**King's Cross Station  
Redevelopment  
Programme Package 6  
GRIP 6**

Listed Building Consent  
Application (Reference  
2006/3394/L);  
Condition LB06;  
Demolition Work  
Approval

Document ref  
ENG-REP-G5-OAP-006-  
SWNS-0218

**Appendix 3  
Revision 1.0**

BASEMENT FLOOR PLAN ZONE 2 - CONSENTED DEMOLITIONS

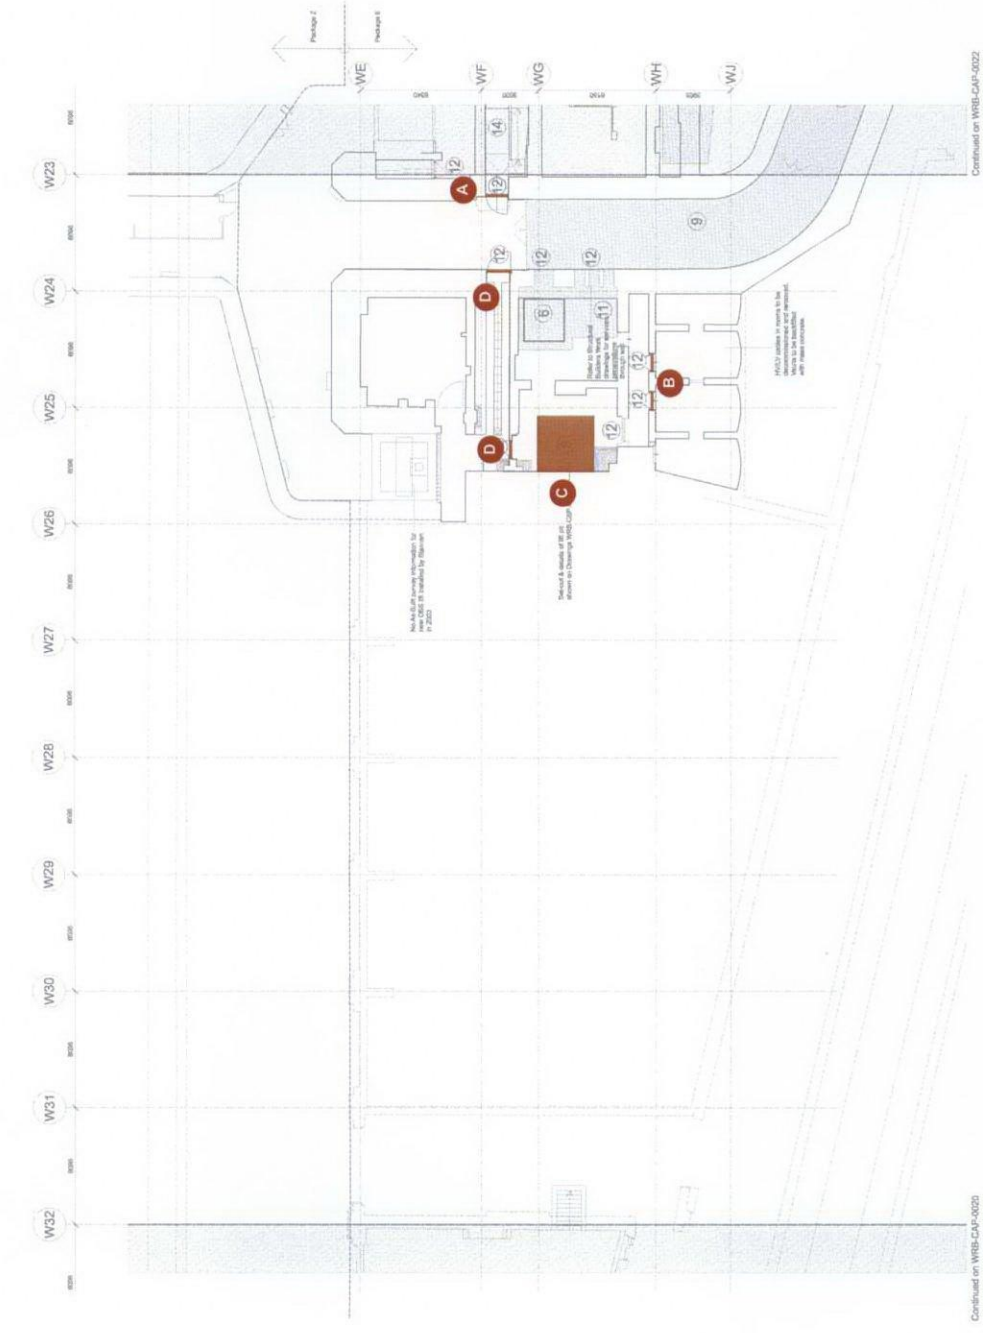
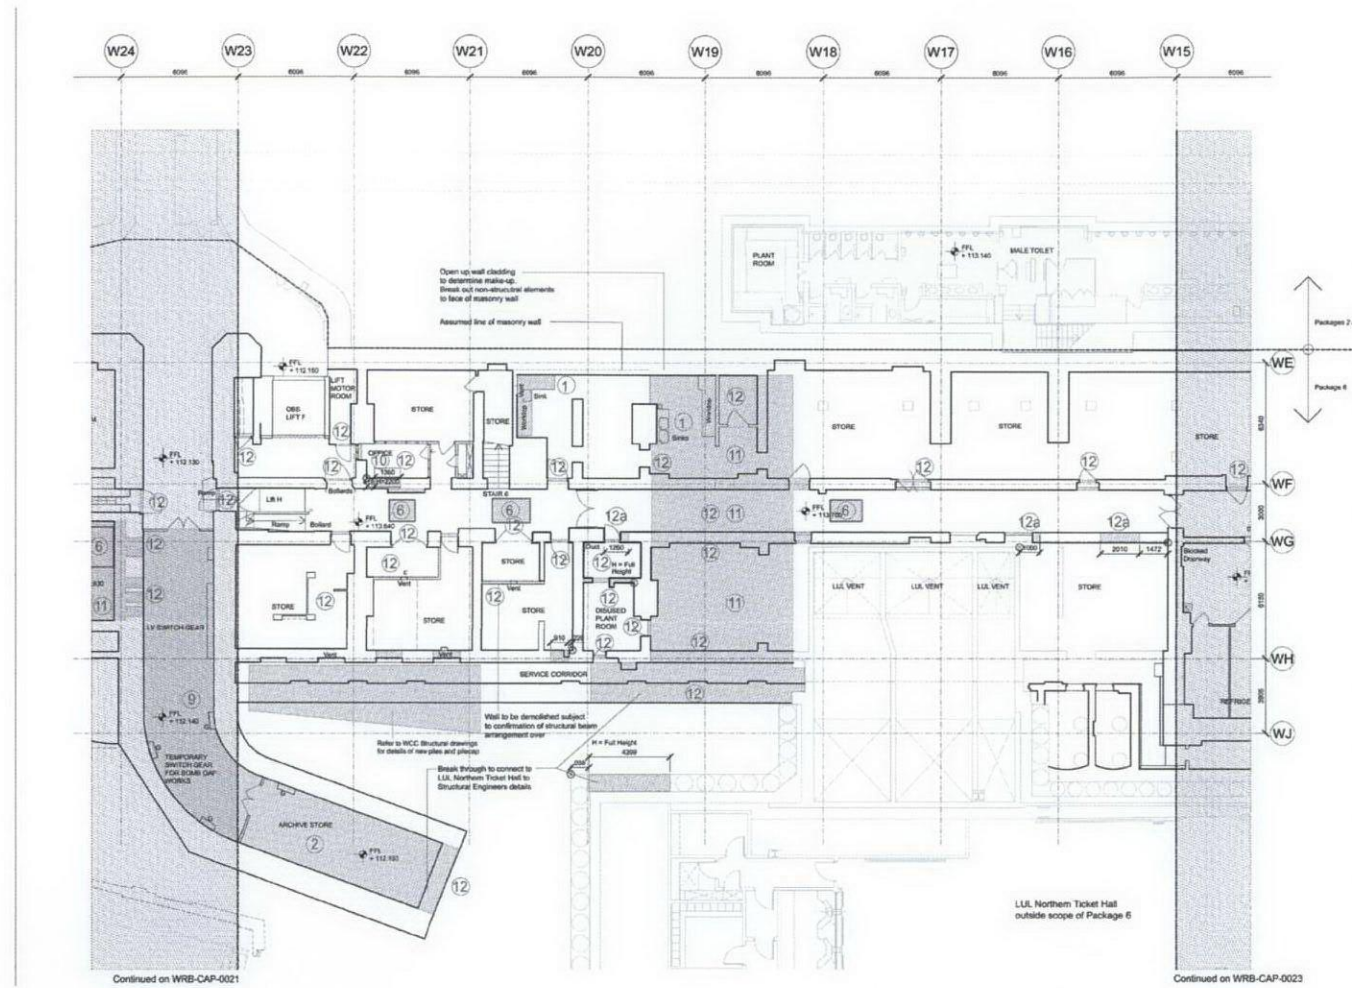
- A** Existing Lift no longer required, new Store to be accommodated
- B** Doors removed, openings infilled and vaults backfilled with mass concrete
- C** Section of floor removed to accommodate new Lift - nature of works covered in consented specification
- D** Doors to be removed or blocked up are non-historic, have been identified as 'not for salvage' and are to be removed as they are no longer fit for purpose

**BASEMENT FLOOR PLAN ZONE 3 – PROPOSED DEMOLITIONS**

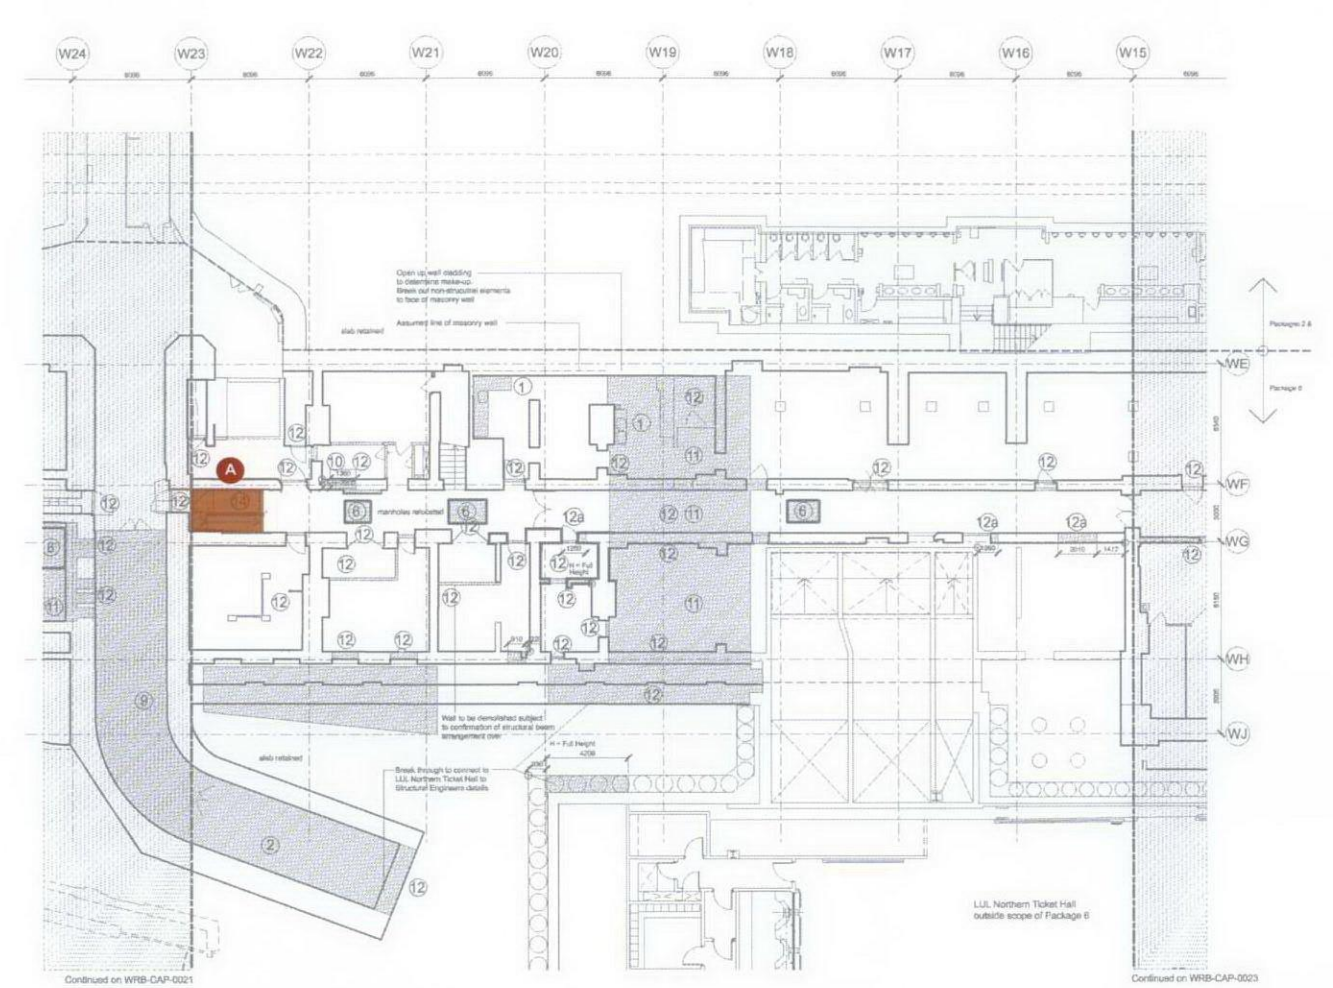
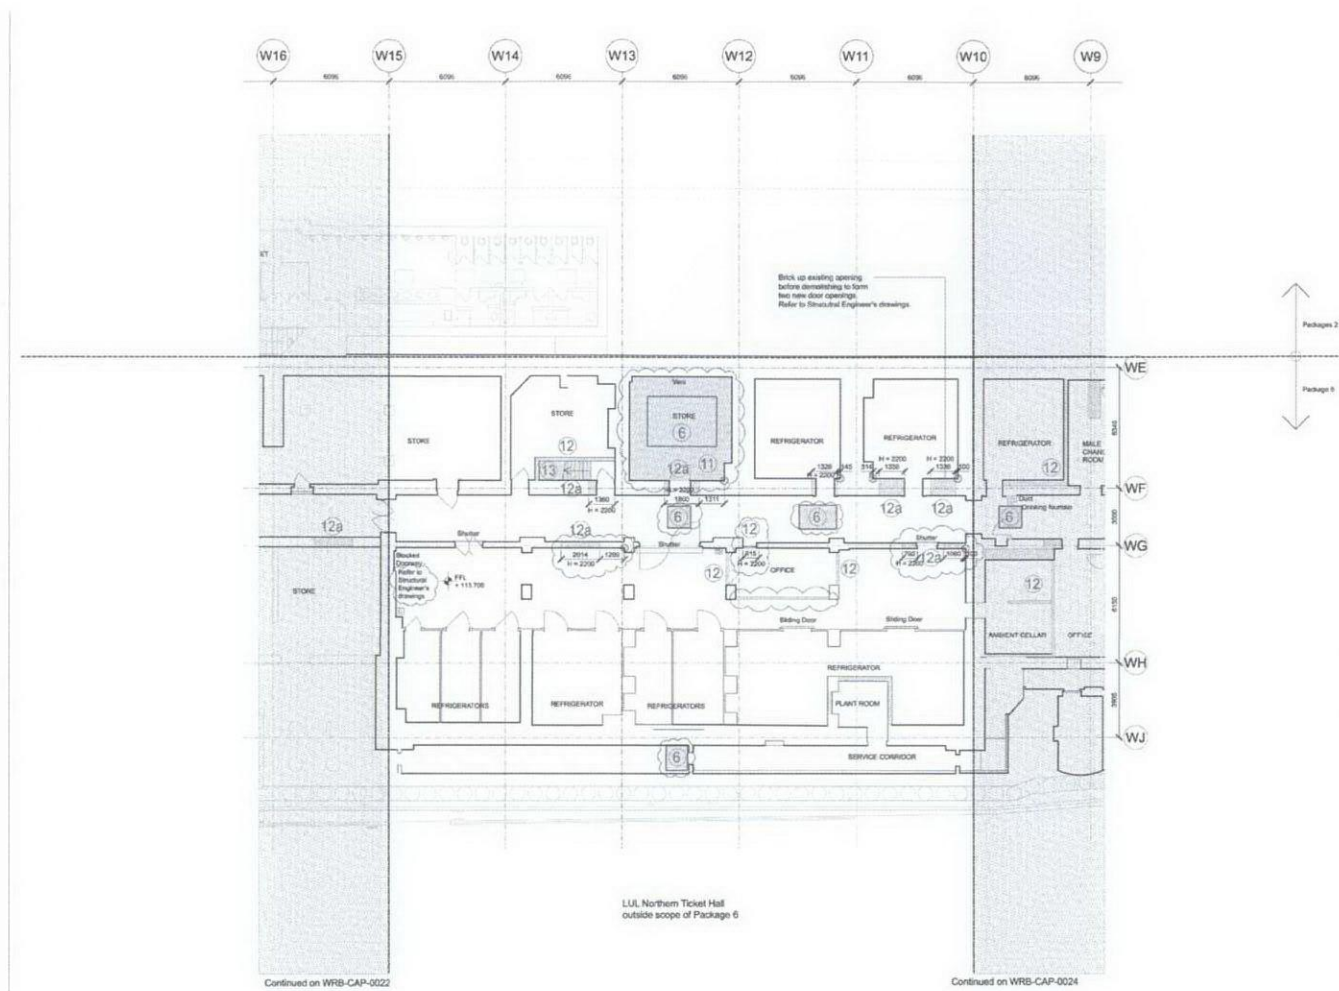
**A** Existing Lift no longer required, new Store to be accommodated

**BASEMENT FLOOR PLAN ZONE 4 - PROPOSED DEMOLITIONS**

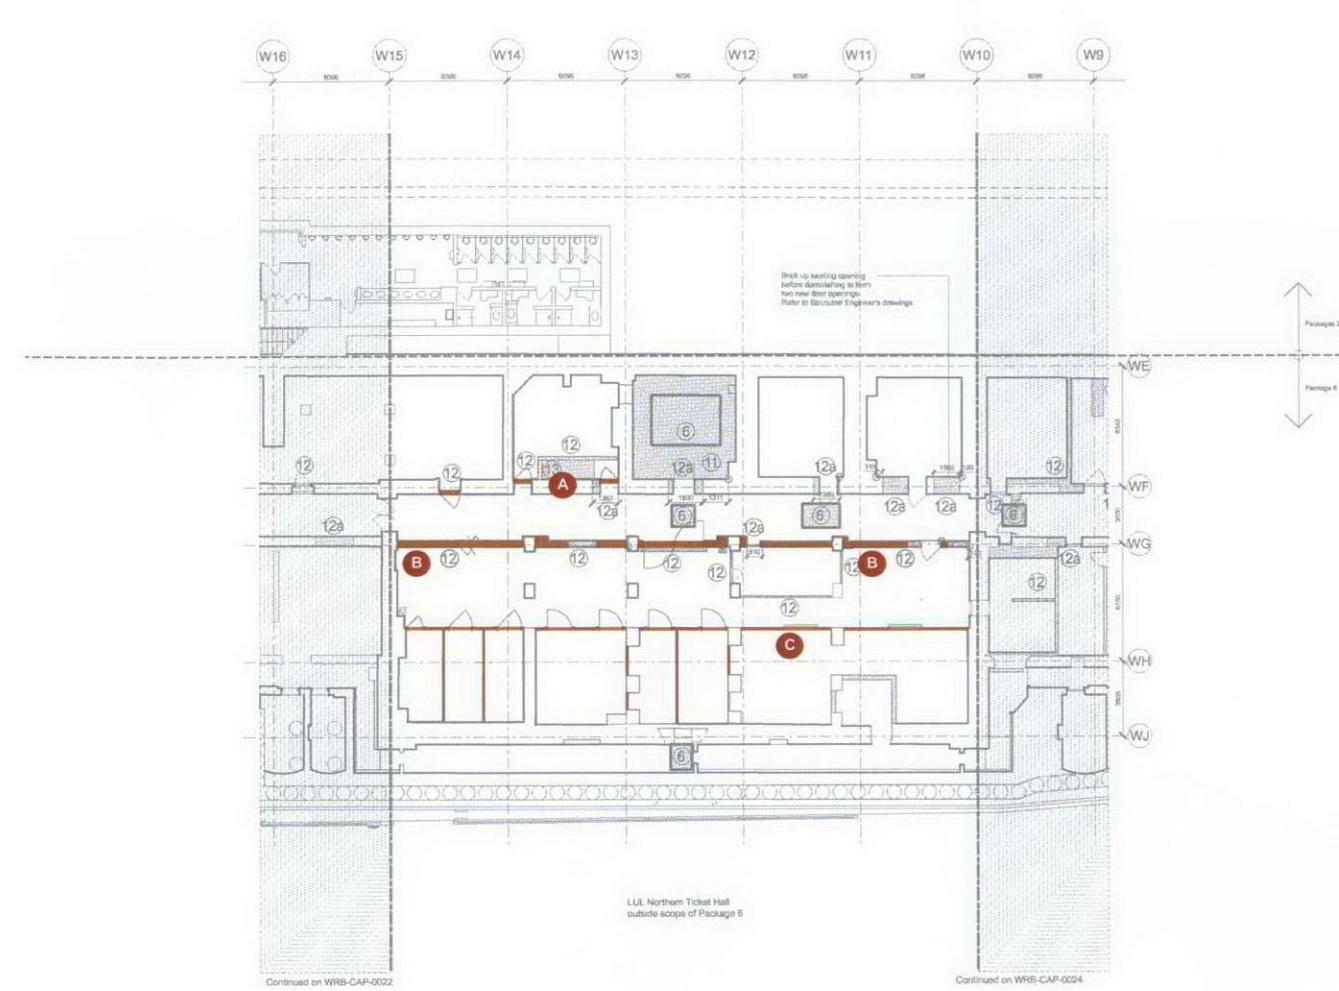
- A** Doors to be removed or blocked up are non-historic, have been identified as 'not for salvage' and are to be removed as they are no longer fit for purpose
- B** Removal of non-loadbearing walls between masonry piers. New On-Board Services Distribution Centre requires free and easy access to corridor space
- C** Removal of Refidgeration partitions not part of heritage fabric are is to be carefully removed as part of the soft strip
